Jemena Revised Regulatory Proposal 2026-31

REVIEW OF COBURG NORTH ZSS REDEVELOPMENT PROJECT

Report prepared for:
**AUSTRALIAN ENERGY
REGULATOR**
March 2026

Figure 2.2: Coburg North - Probability of failure: transformer, circuit breakers and secondary equipment

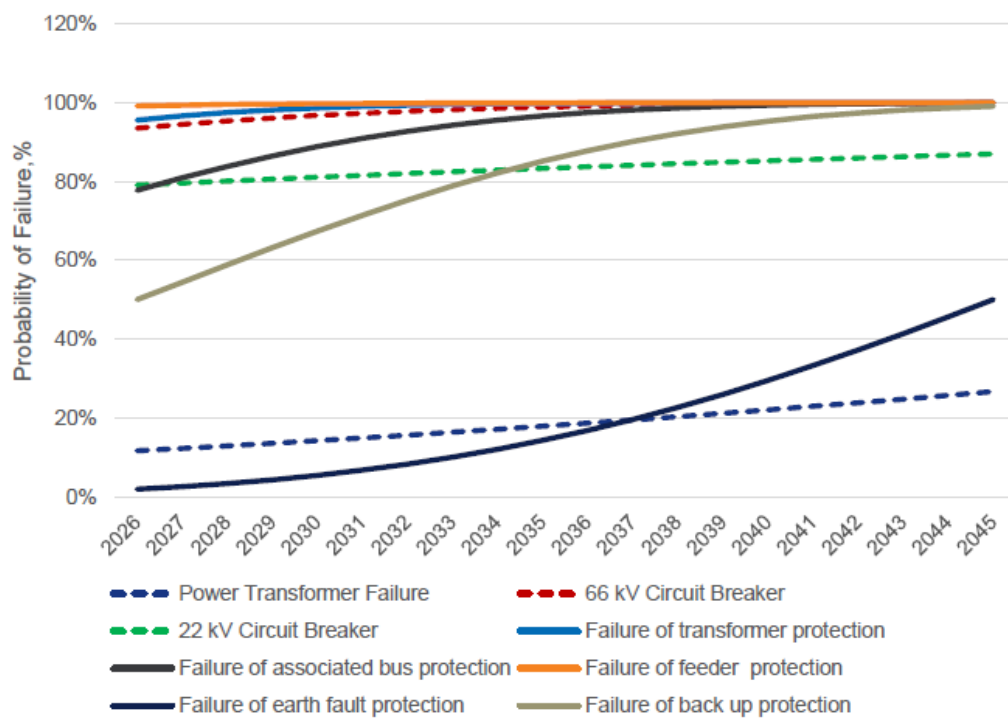
- 80. As shown in Figure 2.2, Jemena is assuming that the failure of transformer protection or failure of feeder protection approaches certainty from 2026, with elevated risks for many of the remaining protections systems and primary plant elements.

Figure 2.3: Asset probability of failure 2025 - 2044²⁴

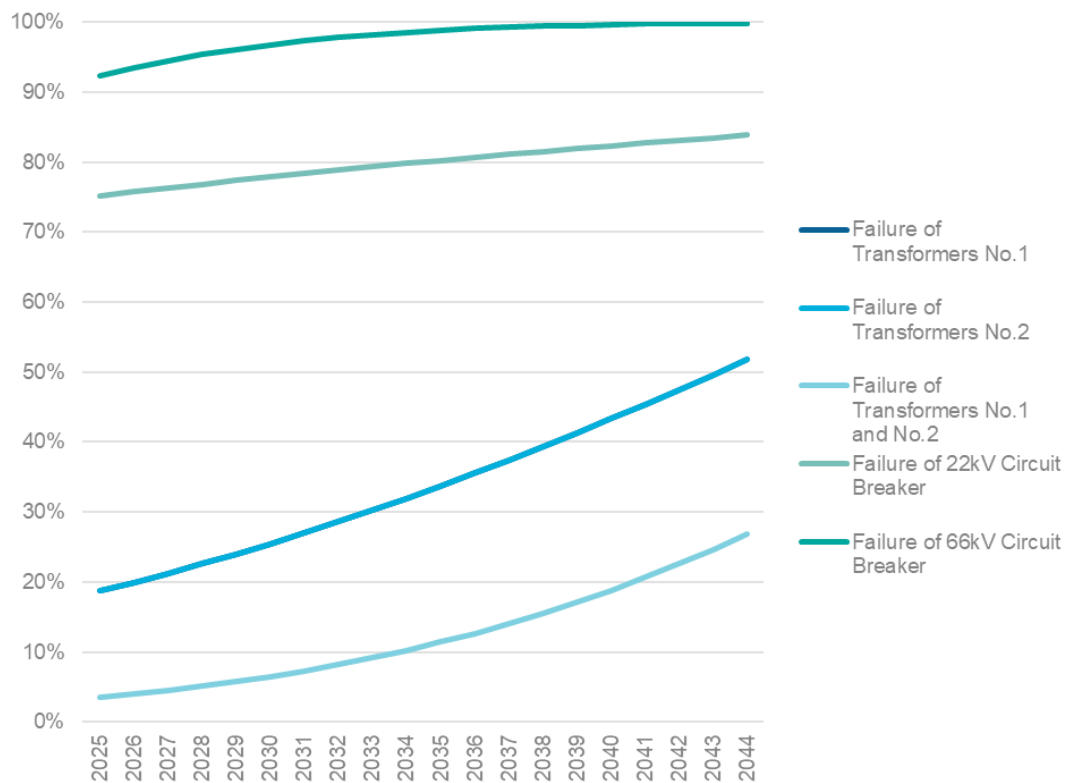
86. Jemena has applied a combination of the Weibull parameters from this paper for failures and retirements as shown in Table 2.4 to produce a composite PoF for transformers No.1 and No.2, which is shown in Figure 2.3.

87. Figure 2.3 also shows the PoF for a 22kV CB and 66kV CB, for comparison purposes and which we review separately.

Figure 2.4: Base case supply risk (\$million, real 2024)

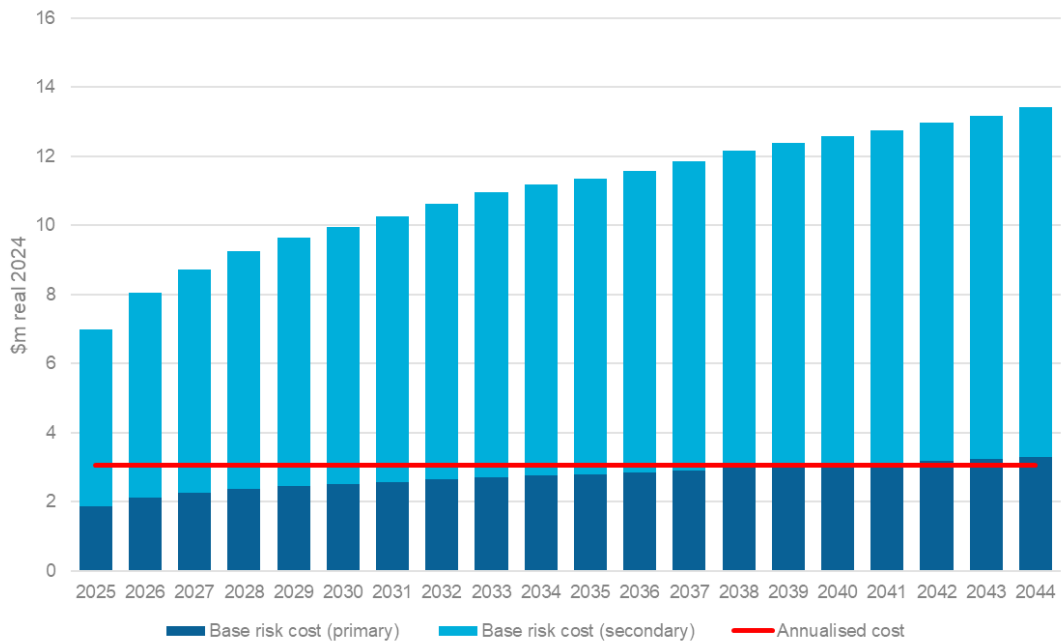
129. From Figure 2.4 we observe that the supply risk assumed by Jemena is approximately \$7 million (\$real 2024) in 2025 and increasing. This exceeds the annuitised cost of the proposed redevelopment calculated by Jemena of \$3 million, and on the assumption that the proposed solution rescues all of the supply risk, the project is already economic to undertake. In reality a residual level of risk continues after Option 3.

137. In both cases, we found that the adjustments did not change the delivery timing of the project. This is not surprising given the large supply risk as shown in Figure 2.4.
